**DOCKET NUMBER 50-483
CALLAWAY PLANT
UNION ELECTRIC COMPANY
LICENSE AMENDMENT REQUEST OL 1258
REVISION TO TECHNICAL SPECIFICATION 3.7.3,
"MAIN FEEDWATER ISOLATION VALVES (MFIVs)"**

**LICENSE AMENDMENT REQUEST OL 1258
REVISION TO TECHNICAL SPECIFICATION 3.7.3,
"MAIN FEEDWATER ISOLATION VALVES (MFIVs)"**

MARKUP OF TECHNICAL SPECIFICATION PAGES

Figure 3.7.3-1 (Page 1 of 1)
MFIV Stroke Time Limit vs Steam Generator Pressure
3.7-8a

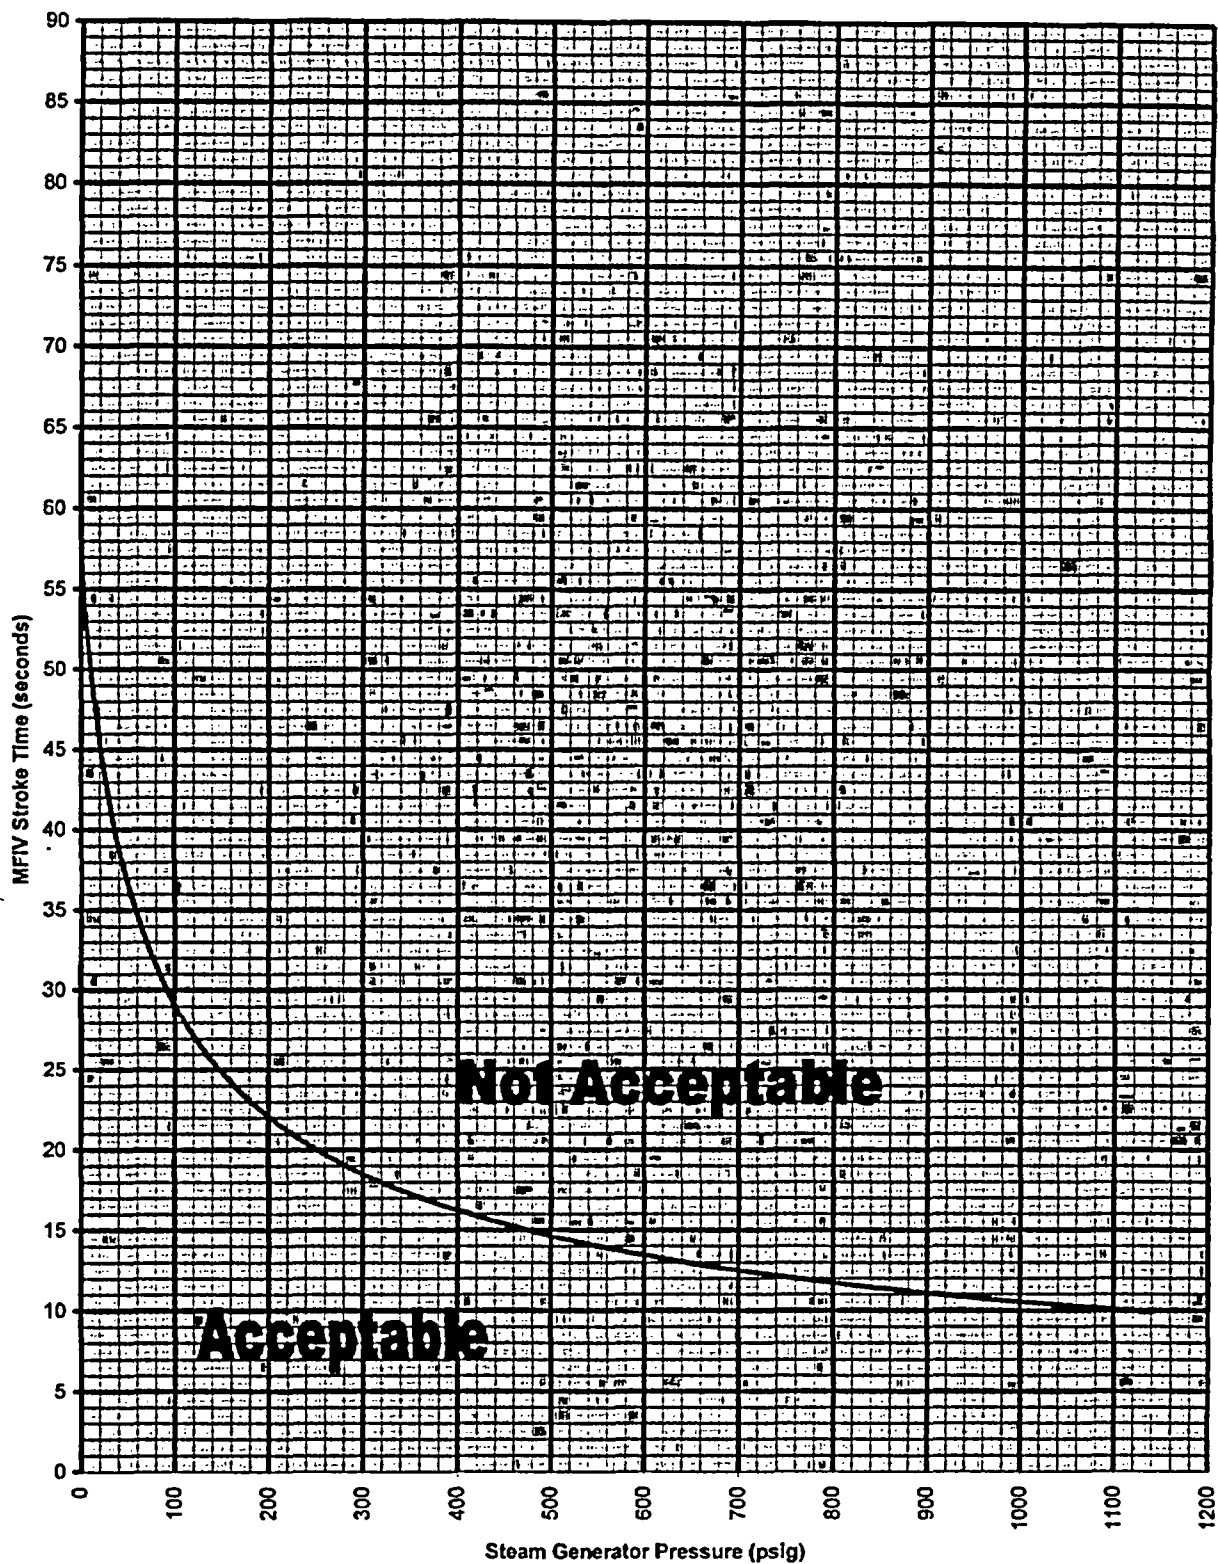
Proposed new SR 3.7.3.3 would specify a stroke-time test requirement more appropriate to the MFIV system-medium actuator design and its associated system-pressure dependent stroke time. Specifically, the statement of proposed SR 3.7.3.3 requires verifying that the closure time for each MFIV is within the limits of Figure 3.7.3-1, which is a new figure that is being added to TS 3.7.3. Figure 3.7.3-1 is a curve of the MFIV isolation time limit as a function of steam generator pressure, in lieu of a single-valued stroke time limit as currently specified. The frequency for performing this surveillance, i.e., for verifying that the MFIV isolation (closure) time is within the limits of Figure 3.7.3-1, would continue to be in accordance with the Inservice Testing Program.

AmerenUE is proposing a revised Technical Specification that will capture the dependency on steam generator pressure of the MFIV stroke time. The proposed TS change provides the requirement that the closure time for each MFIV is within the limits of Figure 3.7.3-1. Figure 3.7.3-1 is a curve of the MFIV isolation time limit as a function of steam generator pressure and provides a variable stroke time for the MFIVs. Having a stroke time limit requirement that is dependent on steam generator pressure enables performance of the required MFIV surveillance at any particular operating condition bounded by the curve.

SR 3.7.3.3 Verify the closure time of each MFIV is within the limits of Figure 3.7.3-1.	In accordance with the Inservice Testing Program
---	---

After receipt of the amendment requested per this application, implementation of the amendment will make Figure 3.7.3-1 effective as the acceptance criterion for the MFIV stroke time test(s) required per SR 3.7.3.3. Proposed Figure 3.7.3-1 is a bounding curve that provides the required MFIV stroke time limit as a function of secondary system pressure. As described in Section 3.0, proposed Figure 3.7.3-1 is based on a performance curve that was established for the MFIVs and validated, in part, by field testing of the valves at various pressures.
